PROPOSALS FOR A NEW MOTORWAY REST AREA ON LAND AT JUNCTION 16 OF THE M4, WILTSHIRE - RESPONSE TO WILTSHIRE COUNTY COUNCIL COMMENTS APPLICATION REF: PL/2023/09142 – JULY 2024 (3728)

This note will set out a consideration of Wiltshire County Council's (WCC) formal consultation response dated 25th January 2024. The WCC comments are provided in **Appendix 1**.

PL/23/09142 Outline application (with Access to be determined) for development of a new Motorway Rest Area (MRA) to provide up to 241 car parking spaces; up to 63 Heavy Goods Vehicle (HGV) parking spaces; coach and caravan parking; amenity building; fuel filling station; new roundabout access from B4005; and associated landscaping, infrastructure and ancillary works

DRAWING TITLE: SWINDON MRA SIGNAGE PLAN

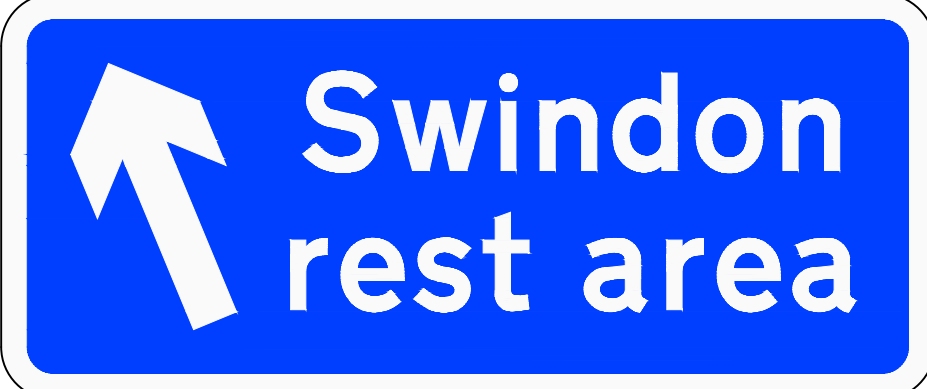
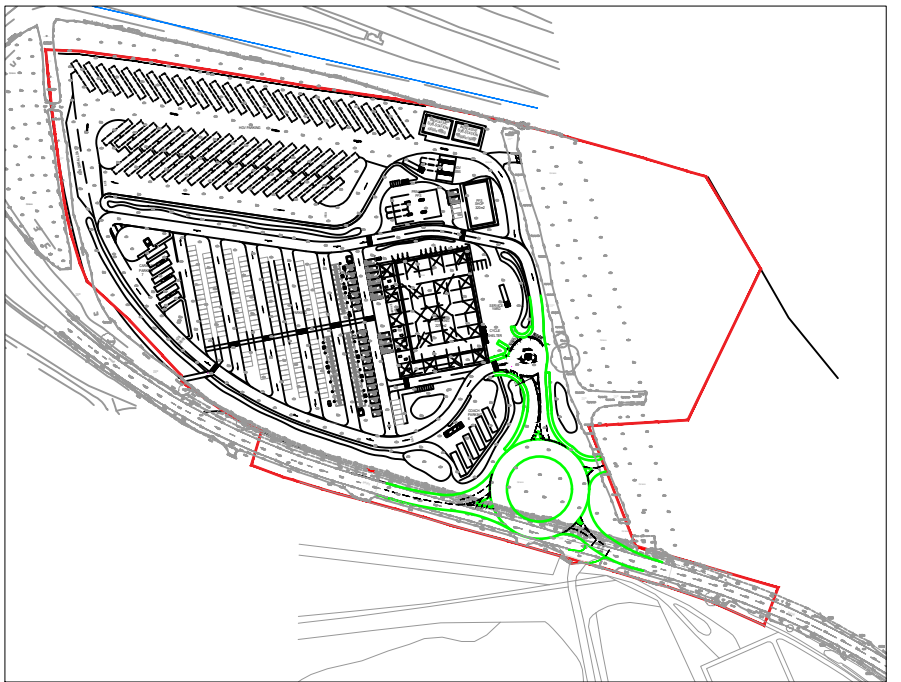
The arrangement of lanes on Junction 16 does raise concerns in terms of possible locations for signing. Controlled pedestrian crossings are in place on the junction and signing should not interfere with driver visibility of vulnerable road users.

It is not possible to establish from the work presented if the signing required can be achieved within the technical requirements for signing of a grade separated junction. We would want to establish this information now to ensure that any associated planning condition was achievable.

Notwithstanding, in order to provide WCC with comfort that the signage as prescribed in the '*Guide to the Signing of Roadside Facilities for Motorists on the Strategic Road Network in England*' can be accommodated on the M4 and at J16, an indicative signage strategy plan has been prepared.

The proposed signage strategy is provided in **Appendix 2**.

This signage strategy plan will be subject to further agreement with NH, however, it is considered that it shows that the appropriate MRA signage can be achieved without any adverse impact on driver visibility or vulnerable road users.

DRAWING TITLE:
PROPOSED FOOTWAY LINK

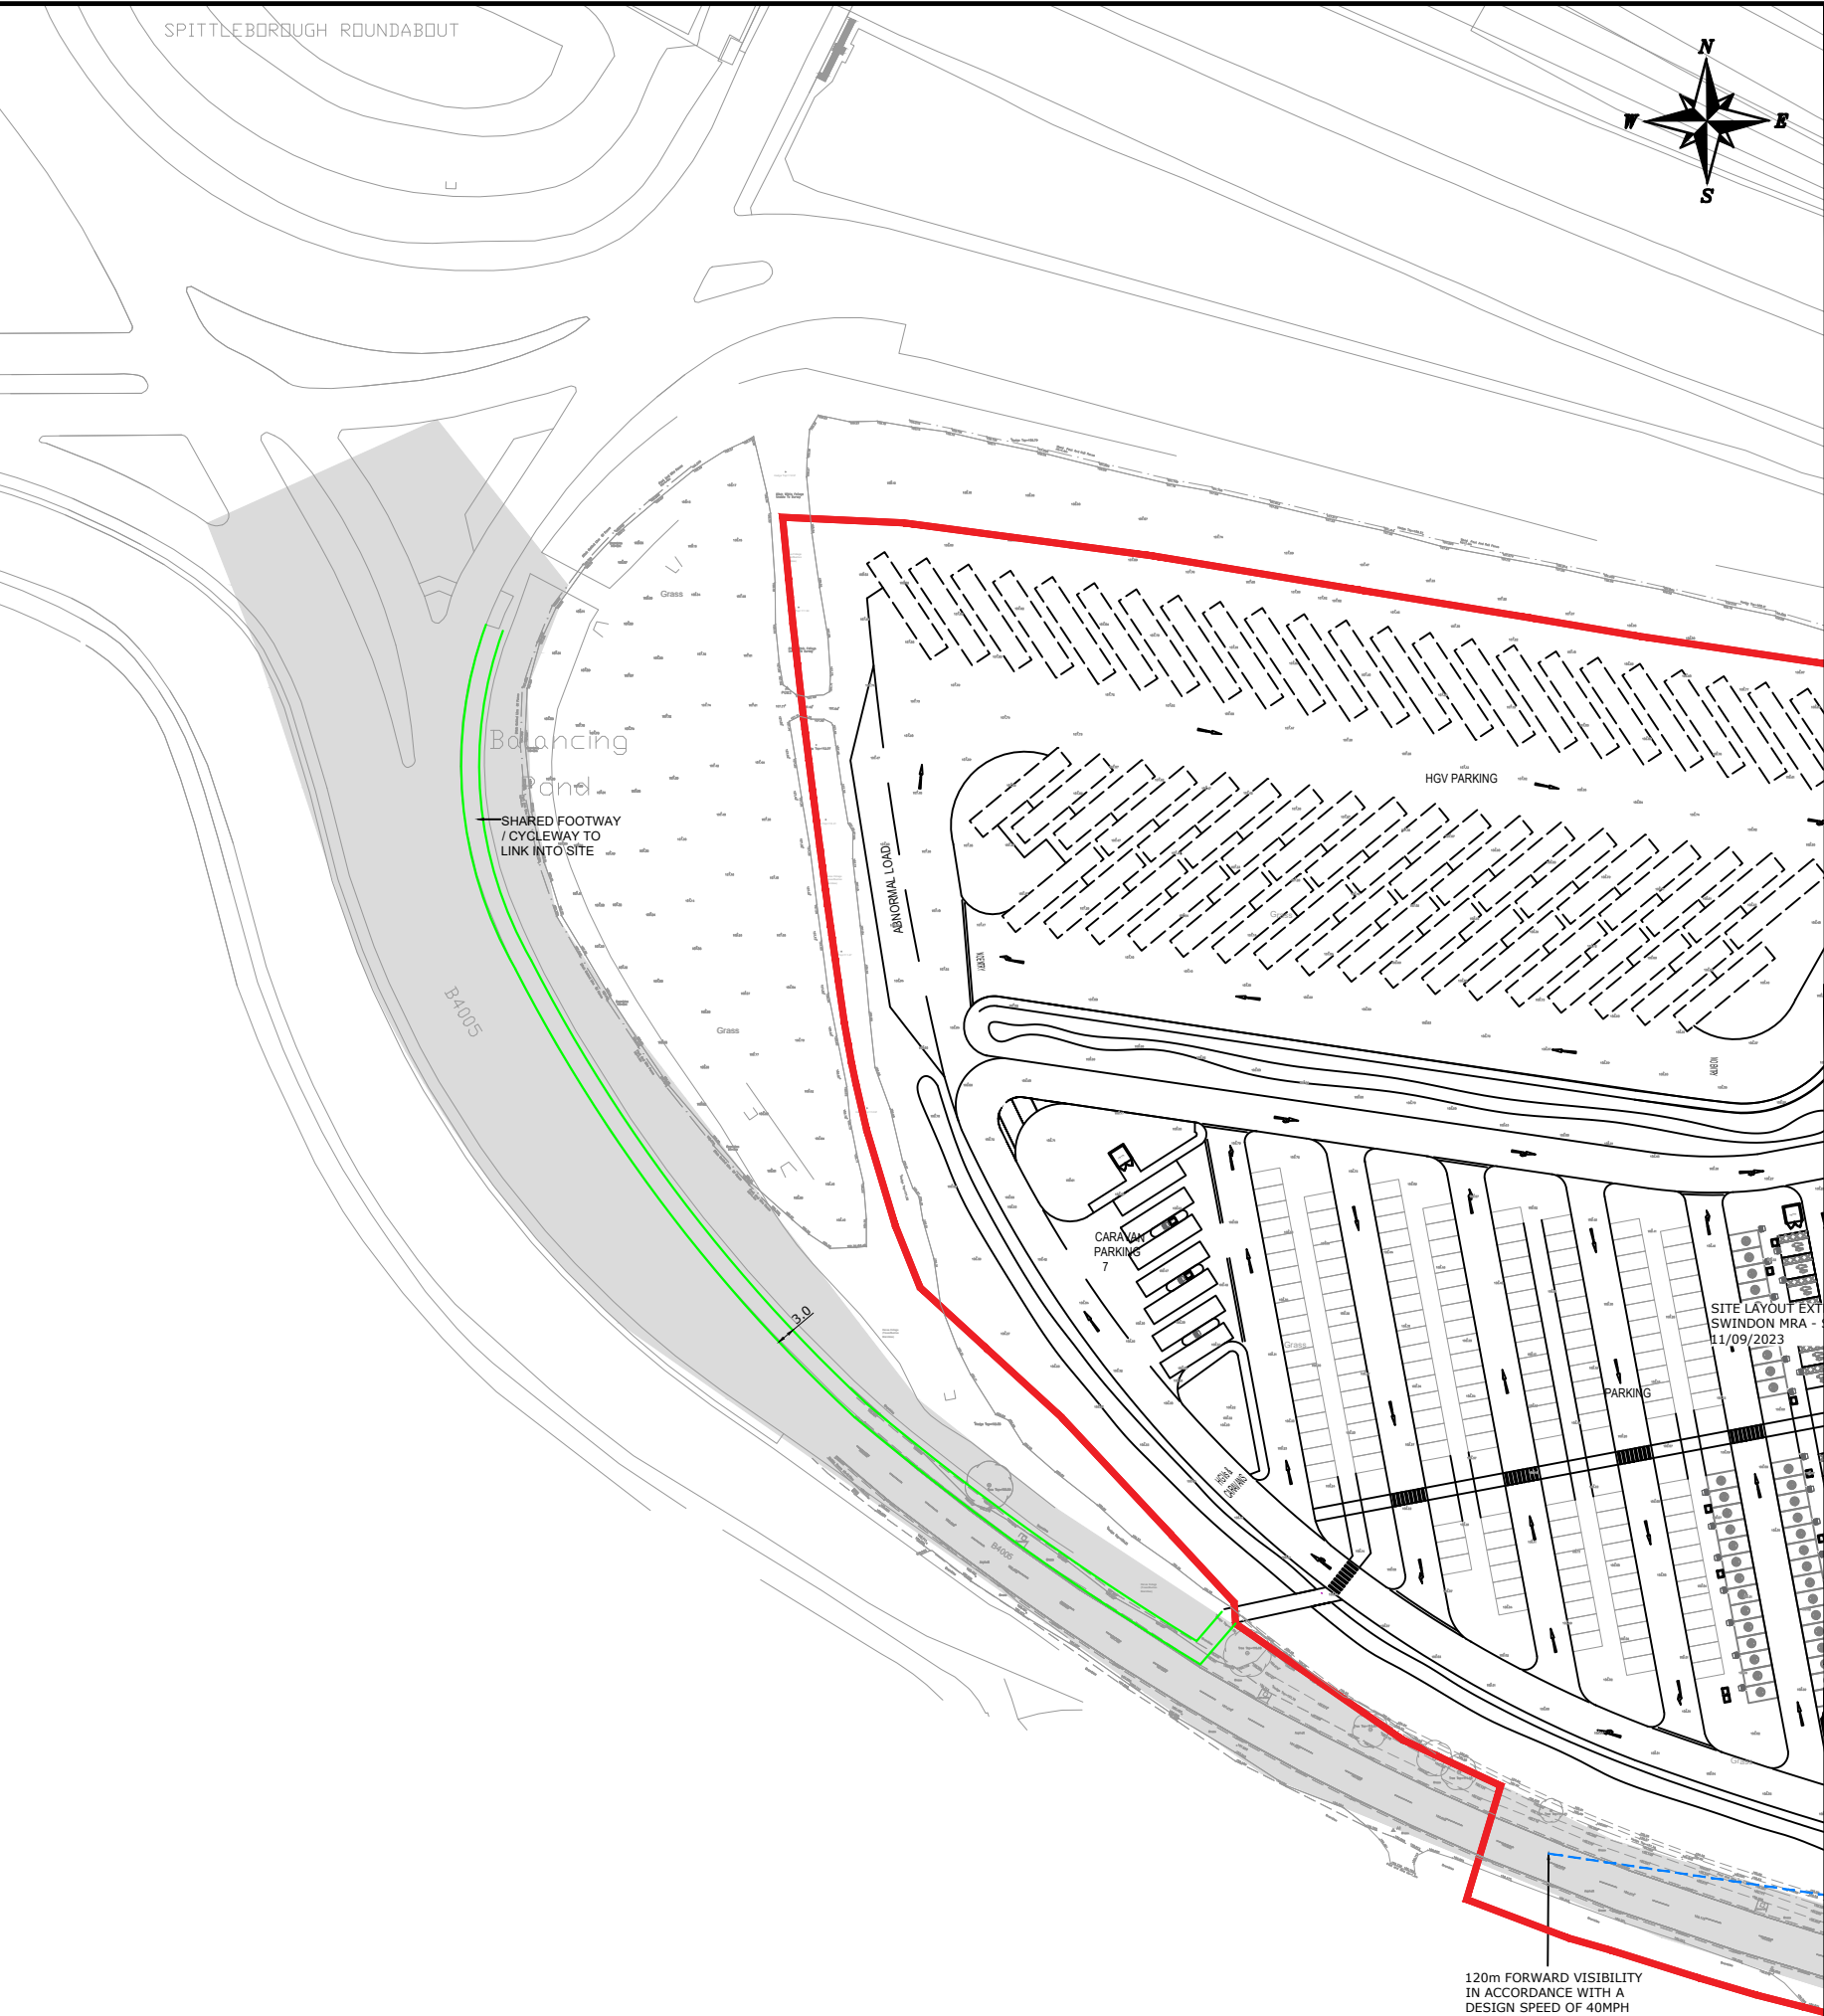
Paragraph 5.2 of the TA notes that there are pedestrian crossing facilities which run out next to the site which would enable people to cross westwards towards the A3102. The pavement along there appears to run out at the crematorium, presumably as the location is served by buses noted by the presence of bus stops. As this facility has been put in place the developer needs to ensure they have linked into it properly. The masterplan does show a link out onto the B4005 road to the south-west of the site, but the existing crossing facility is much further to the west, right on the roundabout. The developer must provide an outline design showing this link and confirm they would provide it. Ideally the link would be out of the very west side of the site to minimise time adjacent to the busy road, this would require an alteration within the site. Whatever is proposed must be a clear and direct link from the crossing locations to the service station entrance. It is appreciated that gradients may make the most direct line difficult, but this will need to be evidenced and understood. Any proposed routes should be 3m wide so anyone walking feels as comfortable as can be reasonably be achieved given the adjacent traffic. Any proposal could also be upgraded to a shared-use facility if additional development

The crossing facilities currently appear not to be in use. Any proposal should be combined with this facility to ensure it is in use prior to first operations / occupations.

WCC have stated that they require a pedestrian link along the southern boundary of the site to ensure a direct connection between the site and the existing pedestrian crossing to the west of the site. This link will be provided by the applicant and is shown in outline in **Drawing Number 3728-F06 Revision C**, appended to this note. Due to land ownership and gradient restraints, this link will need to run adjacent to the carriageway edge, however, it is accepted that a 3.0m wide route can be provided to ensure anyone walking will feel comfortable and to provide the possibility of the route being upgraded to a shared-cycle use route in the future. This link can be subject to an appropriate detailed design condition.

It is also noted and accepted by the applicant that the associated pedestrian crossing facilities which are currently not in use will be brought into use prior to occupation.
